Ribbon Development

1 Wheat Rd
Darling Harbour
SSD-5397

Submission to
Department of Planning
& Infrastructure

Figure 1- Northern Elevation of indicative design of the proposed development

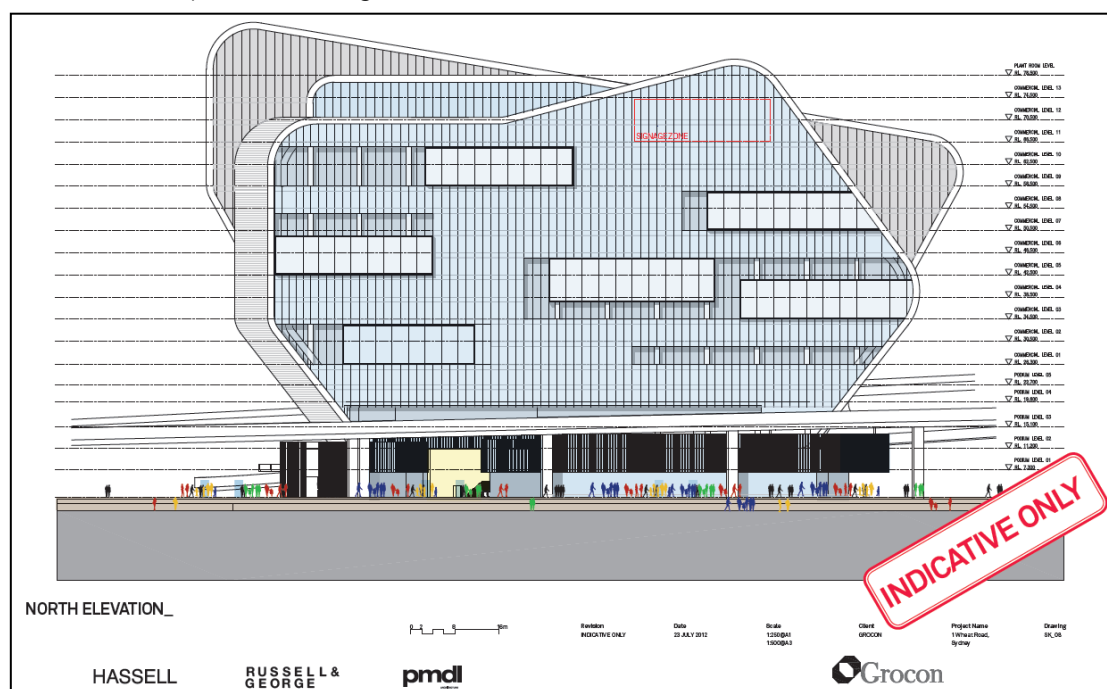
Relevant to matters to be discussed later, the indicative scheme appears to be located totally within its site boundary.

Figure 2 - Northern Elevation of the proposed development submitted with the EIS

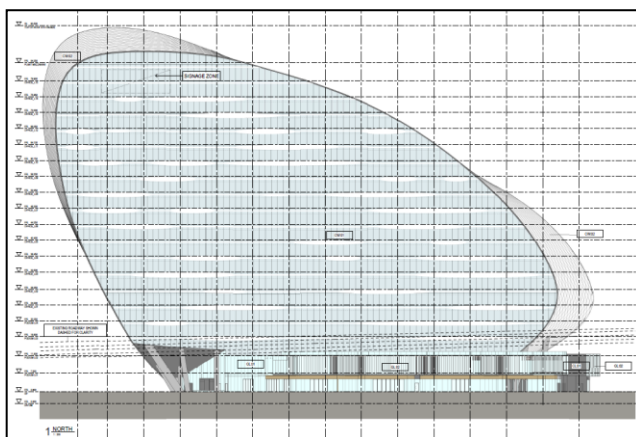
Drawing No ARCH-HSL-DA-1077/A shown in **Figure 2** above, which clearly shows the proposed cantilever over Harbour Street, is not included in the Architectural Plans at Appendix A to the EIS. It is located in Appendix Y of the EIS and entitled "RMS Clearance Diagrams".

The Urban Design Report and the EIS analyse 7 design options, all but one sit totally within the site boundaries (ie the draft lease area). The preferred design Option 7 (**Figure 2**) projects beyond the eastern boundary and cantilevers 18.5m over Harbour St.

No mention is made or justification provided for the necessity or the public benefits, if any, for projection of the development over a public roadway.

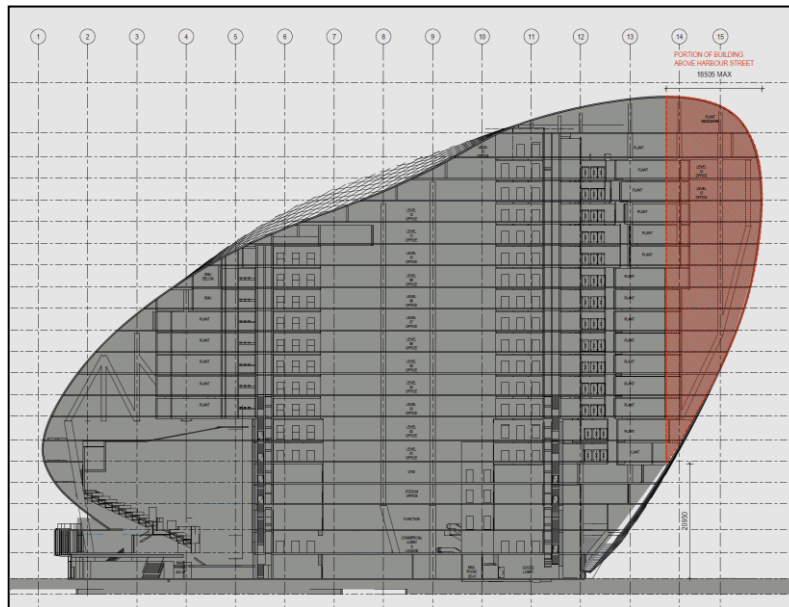
- o The architectural design concept is different and arguably better than the indicative design. No issue is raised with this aspect of the application; however
- o The proposed building is not entirely contained within its site boundaries (the draft lease area). The tallest (90.6m) and most prominent part of the development cantilevers over Harbour Street by some 18.5m (**Figure 3**).

There are 35 architectural plans submitted as Appendix A of the Environmental Impact Statement (EIS). It is noteworthy that none of the architectural drawings explicitly show the cantilevered portion of the building in a manner which would, to a reasonable person, allow an understanding that the eastern portion of the building, rising 90.6m in height, was to be cantilevered 18.5m over Harbour Street.

Figure 8 – Photomontage showing view from living area of apartment B1301 on Level 13 of Emporio building at 339 Sussex Street Sydney together with the proposed development

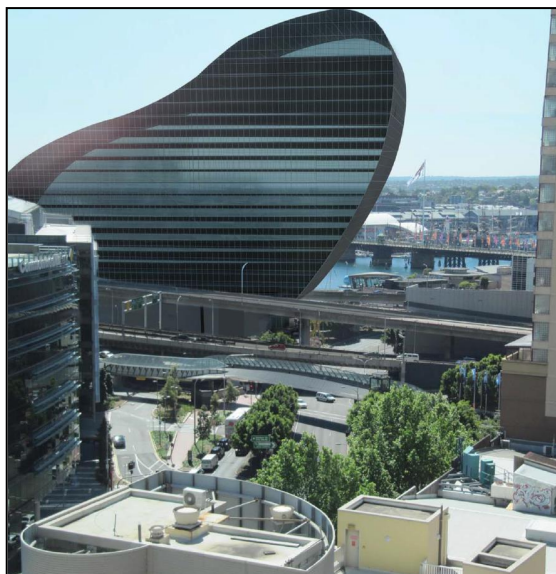
The views lost as a consequence of the proposed development will be those iconic views of Darling Harbour and the heritage listed Pyrmont Bridge; together with Pyrmont beyond (**Figures 7 and 8**).

It is considered that the loss of view to occupants of the upper floors of the Emporio building at 339 Sussex St, as well similarly located occupants in surrounding residential & commercial buildings, arising from the subject development in its current form, would be devastating.

Figure 9 (b) Plan showing 2m separation between façade of the development and the Western Distributor with localised encroachments of 1250mm; thus reducing the separation to 750mm

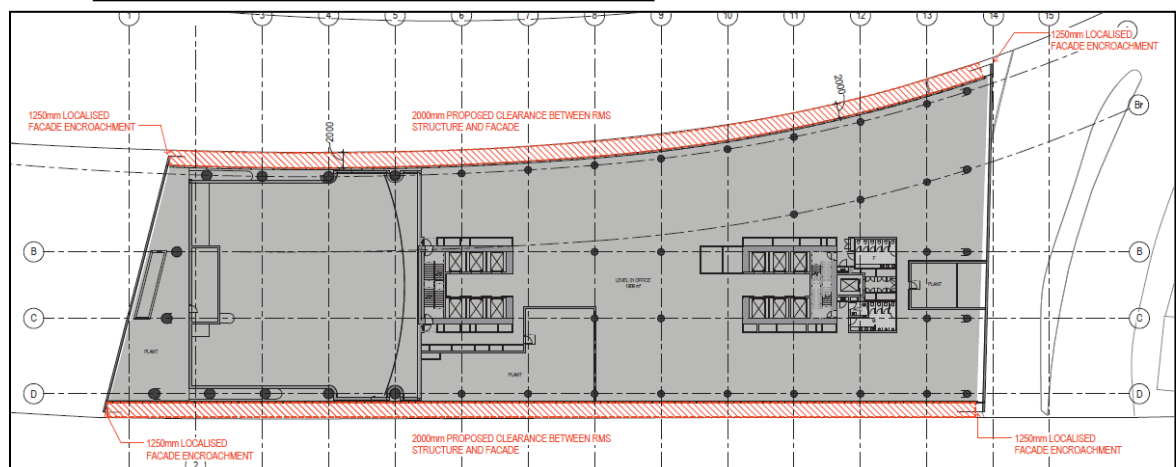
In addition, there has been no assessment of the visual distraction on eastbound and westbound drivers travelling on the Western Distributor by the façade of the development being only 2m from the freeway structure along the 130m (approx.) length of the development; inviting viewing into the building. At the eastern and western corners of the development the clearance to the freeway structure is reduced to 750mm.

Because the building façade is only 2m from the Western Distributor and only 750mm from localised projections, it is considered that the visual distraction to eastbound and westbound drivers will be significantly greater than on other equivalent freeways.

It is therefore considered that the risk of an accident in the vicinity of the building will be proportionately higher. The clearance distances are therefore considered inadequate to provide a satisfactory separation in the event of fire associated with a collision into the expressway structure by one of the many heavy vehicles travelling through the city often carrying highly inflammable fluids.

Figure 10 – Extract from Sydney LEP 2012 showing Maximum Building Heights in the vicinity of the subject development

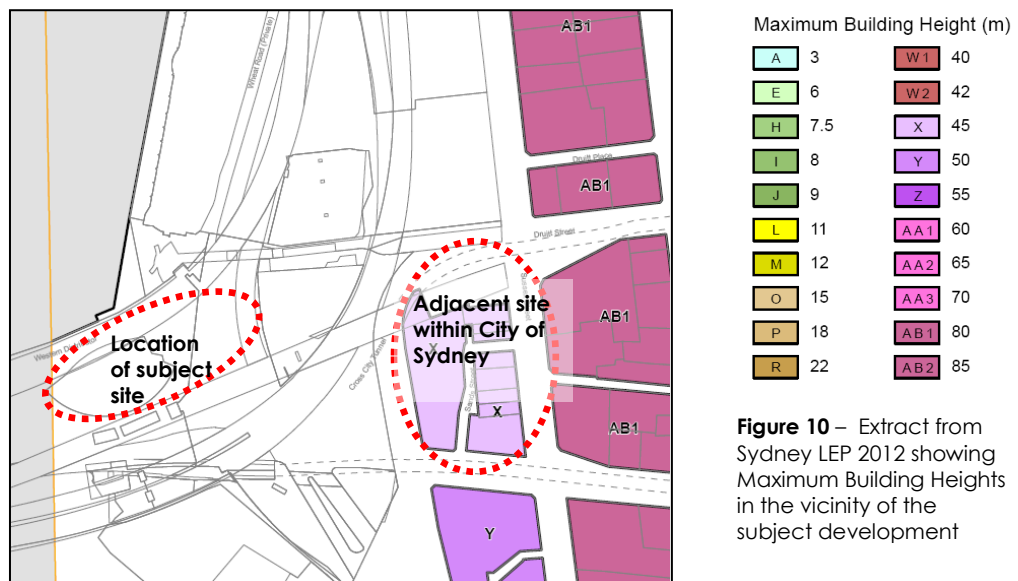
The Sydney LEP 2012 LEP maximum Height in the vicinity of the subject site varies from 45m (Area X), 50m (Area Y) in Harbour St to the immediate south and rising with the rising landform to 80m (Area AB1) in Sussex St to the east (**Figure 10**).

It is considered that the proposed development with an FSR of 14.67:1, a height of 90.6m and a length of approx 130 m on the harbour edge is contextually inconsistent and inappropriate in terms of bulk and scale with adjacent development in the City of Sydney which is limited to an FSR of 7.5:1 for commercial development and a height of 45 to 50m.

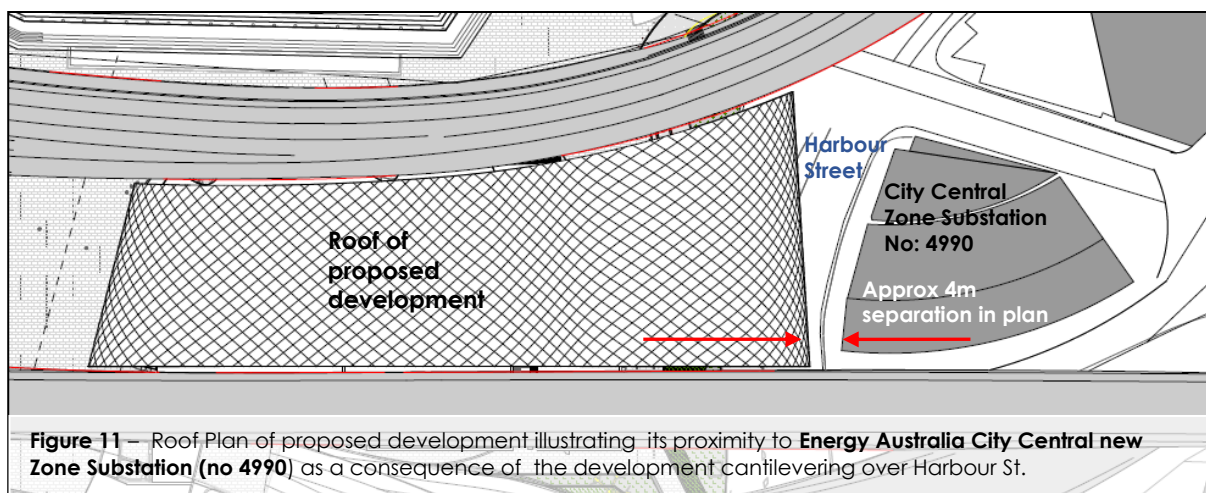
It is considered unlikely that the designers of the City Central Zone Substation (No: 4990) would have anticipated a multi-storey commercial development being built over Harbour Street in proximity to the substation facility.

The EIS has not assessed the potential long term impact of Electromagnetic Field radiation on the workers and visitors within the adjacent projecting portion of the subject development. Nor is there an assessment of the potential impact of a fire and/or explosion within the adjacent City Central Zone Substation on the cantilevered portion of the proposed development and its occupants.
